UNITED STATES PATENT AND TRADEMARK OFFICE

10/757,255

Office Action Summary

DETAILED ACTION

I.

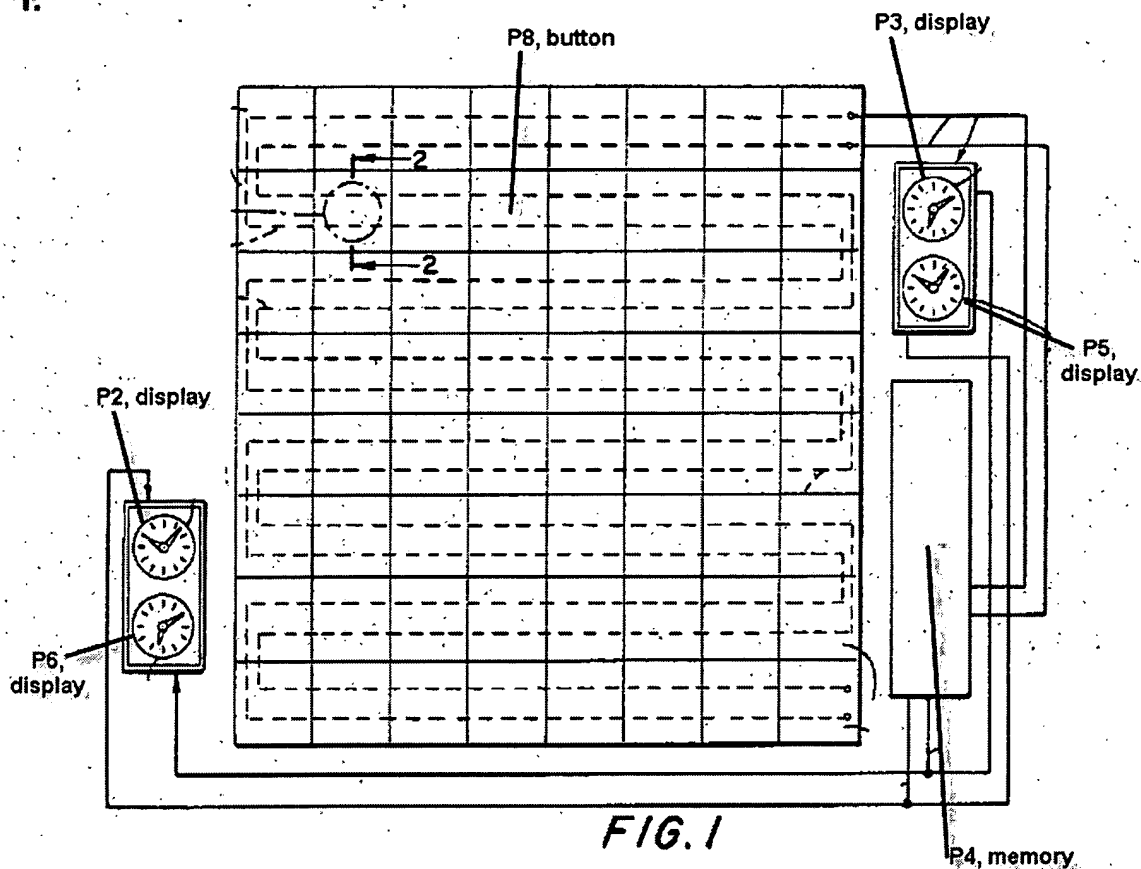
12. With respect to claim 1 Klein discloses a device for displaying information about a game comprising: a body (chess board, P1, picture I. provided below, 10, figure 2); a first display (P2, picture I. and 30 figure 1) operable to display first information about a player of the game; and a second display (P3 picture I. and 32 figure 1) operable to display second information about the player of the game, the second display facing in a different direction from that of the first display, in which the first display and the second display are attached to the body (displayed are attached by wires.)

14. With respect to claim 3 Klein discloses a device for keeping time comprising: a chassis (P1 picture I.); a first memory (P4 picture I.) for storing a first amount of time remaining for a first player of a game, the first memory attached to the chassis (column 2 lines 21-23); a first display (P2 picture I.) for displaying the first amount of time, the first display attached to the chassis (by means of wires) and coupled to the first memory (P4, picture I.); a second display (P5, picture I.) for displaying the first amount of time, the second display attached to the chassis and coupled to the first memory, in which the second display faces in a different direction from that of the first display (depending on the arrangement the displays can face in the same direction or a different direction. The consoles, P2 and P3, while attached to the chassis are not constrained from changing their orientation, face, to be different from that of the chessboard, P1. If the device were placed on a curved table, if the displays were constructed such that they were not level than the displays would face in different directions, or even if a player manually tilted a display so as to better read it the displays P2 and P3 would face in different directions); a second memory (P4) storing a second amount of time remaining for a second player of the game, the second memory attached to the chassis (P1); a third display (P5, picture I.) for displaying the second amount of time, the third display attached to the chassis and coupled to the second memory; and a fourth display (P6 picture I.) for displaying the

16. With respect to claim 5 Klein discloses the device of claim 3, in which the first display and the third display are the same display. (This claim is unclear, please see objection to claim 5 above. As it is currently put forth the claim language is in contradiction with the independent claim 3 of which it depends. Based on the specification I am interpreting applicant's meaning to be that the first display and the third display are part of a larger display, that each display constitutes a part of a larger single display. Given this interpretation Klein discloses the limitations of claim 5, please see P2 and P6 picture I.)

18. With respect to claim 7 Klein discloses the device of claim 3, in which the first memory and the second memory are the same memory. (P4 picture I. and 50 figure 1. Please see objection to claim 7 above. The memory P4 has an on and an off state.)

19. With respect to claim 9 Klein discloses the device of claim 3, in which the first memory comprises a gear. (The memory is in the form of the mechanical structure that drives the display for P2. P5 connects to said memory by electrical means, namely wires.)

23. With respect to claim 14 Klein discloses a device comprising: a means for tracking a first time (clock P2, picture I.); a means for tracking a second time (clock P3, picture I.); a first display means (P2) for displaying the first time in a first direction; a second display (P5) means for displaying the first time in a second direction; and an initiation means (combination of buttons P7, board, and memory P4 picture I.) for initiating the reduction of the first time and halting the reduction of the second time.

FIG. 1

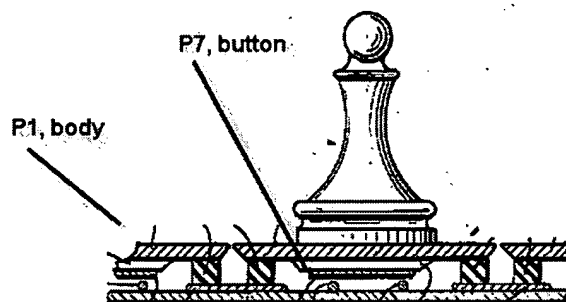
20. With respect to claim 10 Klein discloses the device of claim 3, in which the first display is at least one of: (a) a liquid crystal display; (b) a dot matrix display; (c) a diode display; (d) a light emitting diode display; (e) an organic light emitting diode display; (f) a cathode ray tube; (e) a projection display; (f) a mechanical display (P1, picture I. and 30 figure 1); and (g) a mechanical clock face (P1, picture I. and 30 figure 1).

22. With respect to claim 12 Klein discloses the device of claim 3, further including a processor (the processor is the system made up of the wiring, the board P1, the memory P4, and the timing control means present in each console 30 and 32 figure 1), the processor attached to the chassis and operative to: direct the first memory to reduce the first amount of time remaining; direct the second memory to reduce the second amount of time remaining; direct the first memory to stop reducing the first amount of time remaining; direct the second memory to stop reducing the second amount of time remaining; direct the first display to display the first amount of time; and direct the second display to display the first amount of time (the wiring in the board P1 and the buttons P7, send the signals that switch memory P4 to operate the timing mechanisms in consoles 30 and 32 figure 1.)
